This Service Information bulletin supersedes SI M71 01 15 dated January 2015.

Recall Campaign 15V-034: Replace Vehicle Identification Number (VIN) Label and Tire Label on Left B-Pillar

F56 (Cooper Hardtop 2-door)

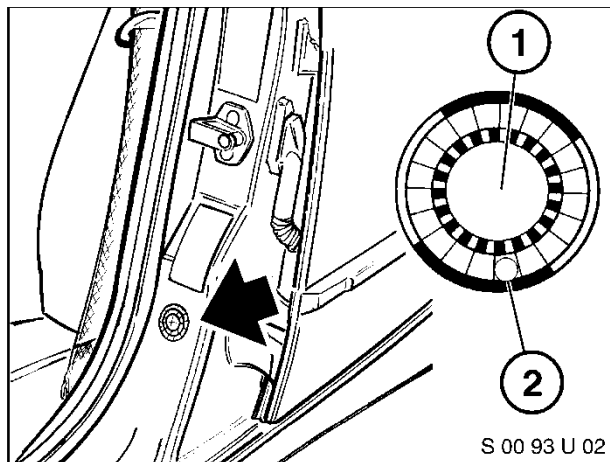
The gross vehicle weight rating (GVWR) displayed on the VIN label, which is affixed to the vehicle's left B-pillar, is too low.

The vehicle capacity weight value displayed on the tire label, which is affixed to the vehicle's left B-pillar, is too low.

The maximum vehicle load (on the tire label) and gross vehicle weight rating (GVWR, on the VIN label) have been increased.

Note: The photo shows the location of the changed specifications, and does not indicate the correct values.

Remove the tire pressure label (upper arrow) and the VIN label (lower arrow) from the driver's B-pillar.

Compare the new label versus the old label to verify that the VINs match and the GVWR is different (has increased) **before the old label is removed!**

- Carefully use a heat gun to soften the adhesive backing on each label.
- Remove the label with a plastic wedge.

Remove all adhesive residue from the B-pillar with an appropriate cleaner (brake cleaner, rubbing alcohol).

Apply the new labels at the same position and with the same orientation as the original label.

- Press firmly on the entire surface and all edges for maximum adhesion.
